Airworthiness Directives; Eurocopter France Model AS-365N2, AS 365 N3, EC 155B, EC155B1, SA-365N, N1, and SA-366G1 Helicopters

ACTION: Notice of proposed rulemaking (NPRM).

Eurocopter France: Docket No. FAA–2004–18850; Directorate Identifier 2004–SW–19–AD. Revises AD 2004–16–15, Amendment 39–13771.

Figure 1

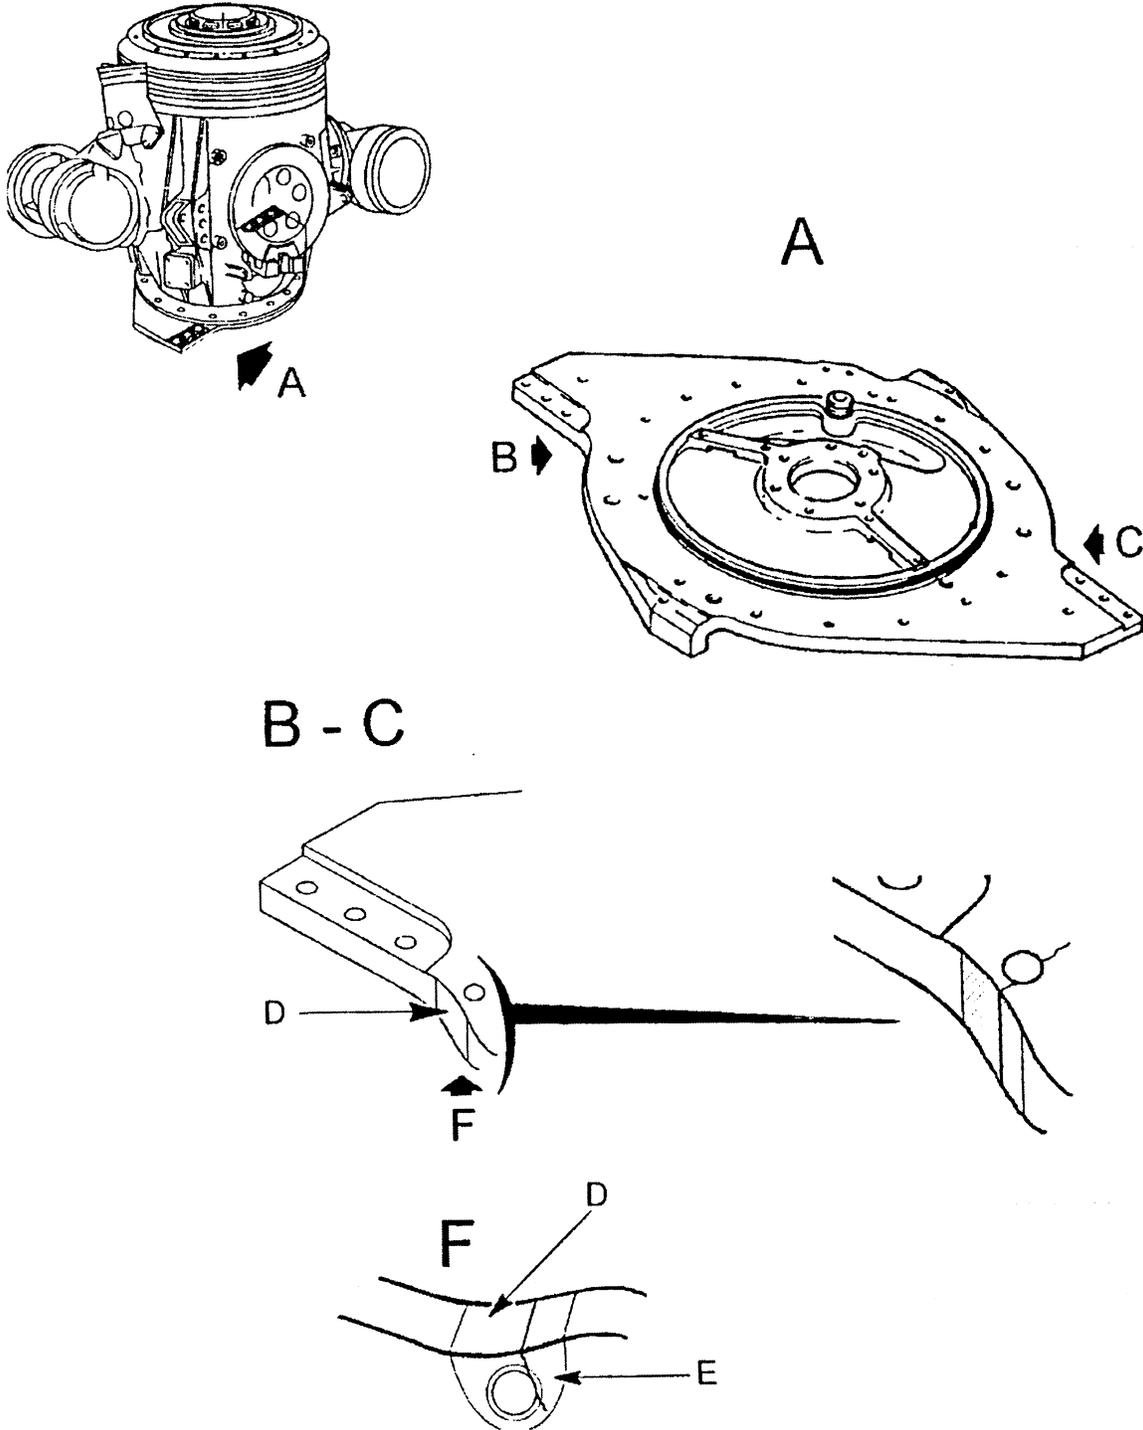
strip the paint from area "D" on both sides ("B" and "C") of the MGB base plate as depicted in Figure 1 of this AD.

(b) At the times indicated in the compliance table, inspect area "D" of the MGB base plate for a crack using a 10x or higher magnifying glass. Area "D" to be inspected is depicted in Figure 1 of this AD.
